**Technical Service
Information Bulletin**

ECM CALIBRATION: SHIFTING ENHANCEMENT

'04 RX 330

TRANSMISSION & CLUTCH
TC005-03

Figure 1. Location of Authorized Modifications Label on 2004 RX 330

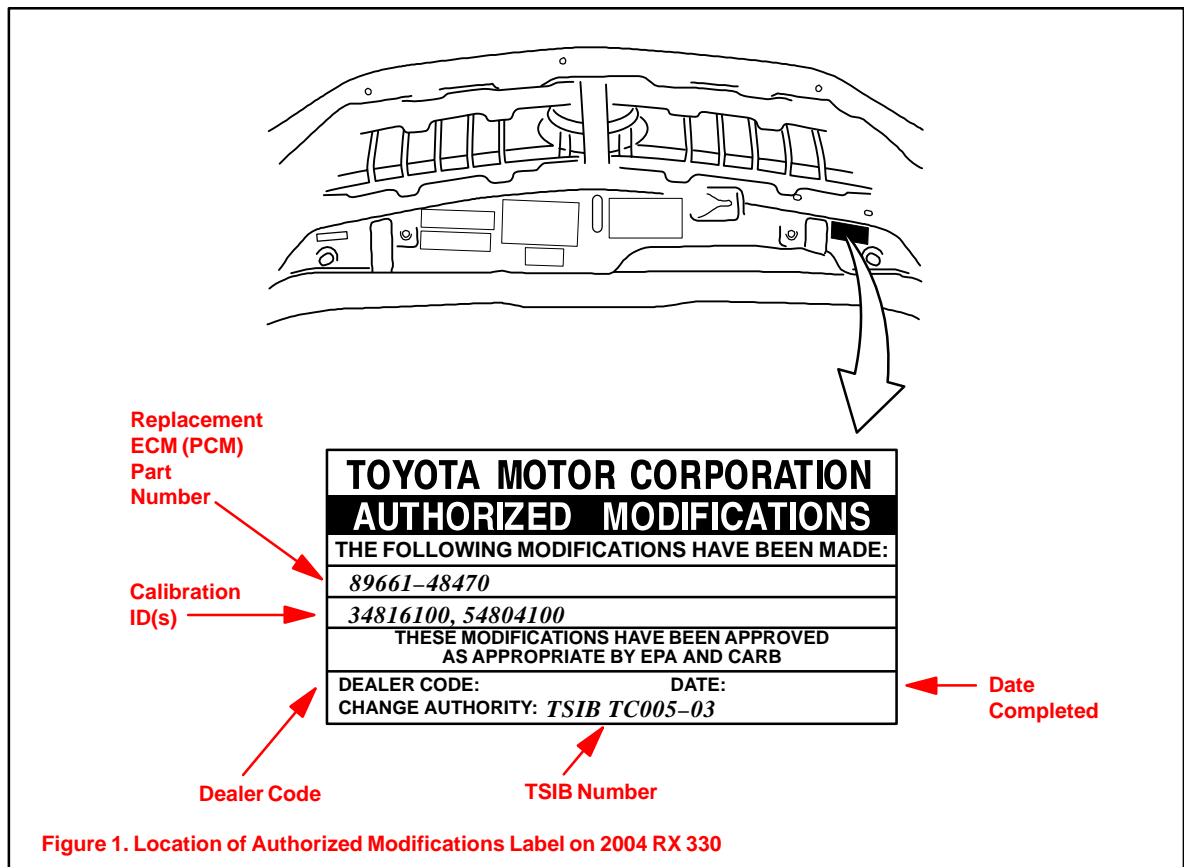
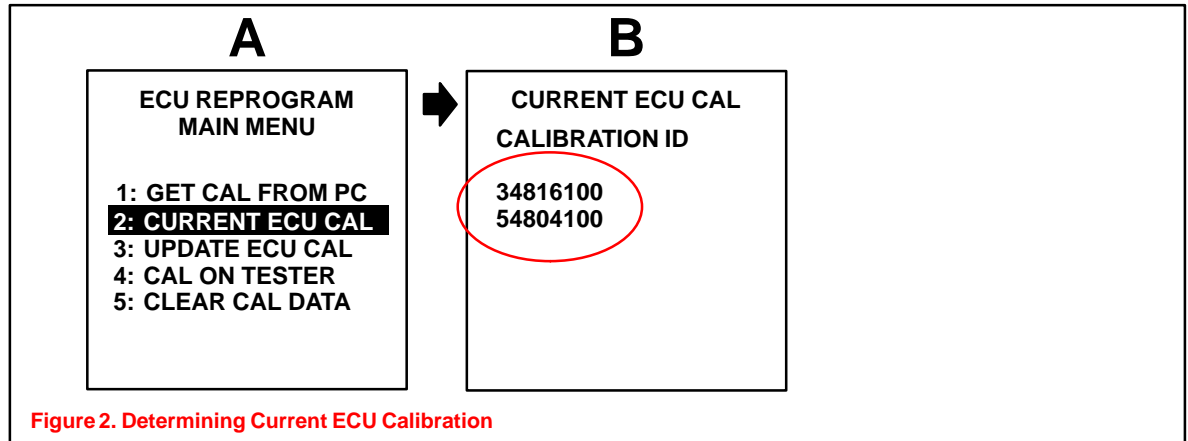
1. Check for the Authorized Modifications Label affixed to the vehicle in the location shown in Figure 1. Confirm if ECM (PCM) calibration has been updated. If not latest ECM (PCM) calibration – go to step 2.

3. Start the engine and warm it up to normal operating temperature before test-driving.
4. Test drive vehicle to confirm proper vehicle operation.
5. Enter the required information on the Authorized Modifications Label and affix it to the vehicle at the location shown in Figure 1 (page 2). The Authorized Modifications Label is available through the MDC, P/N 00451–00001–LBL.
6. Calibration update is complete.

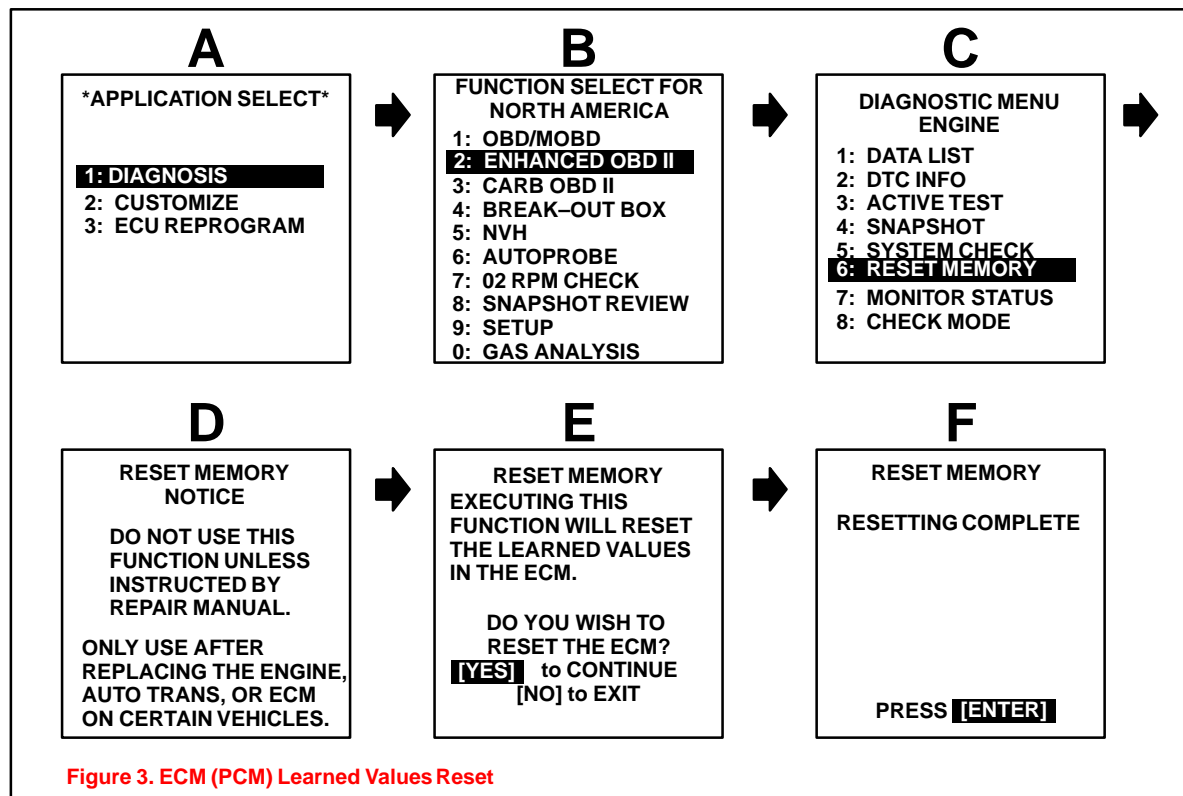
2. Connect the Diagnostic Tester to the vehicle and select CURRENT ECU CAL from the ECU REPROGRAM MAIN MENU. Determine the vehicle's current ECU calibration (see Figure 2).
 - The sample screen prints seen below are the 10.1a software version, and may differ from subsequent software versions.

- If Calibration ID matches “Previous Calibration ID” as shown in Calibration Identification Chart on page 2, proceed with flash reprogramming.
- If Calibration ID matches “New Calibration ID” as shown in Calibration Identification Chart, this vehicle has already been programmed. Refer to Repair Manual for diagnosis.

3. If ECU calibration ID is not the same as the “New Calibration ID” listed previously, proceed to Flash Reprogram ECM (PCM).
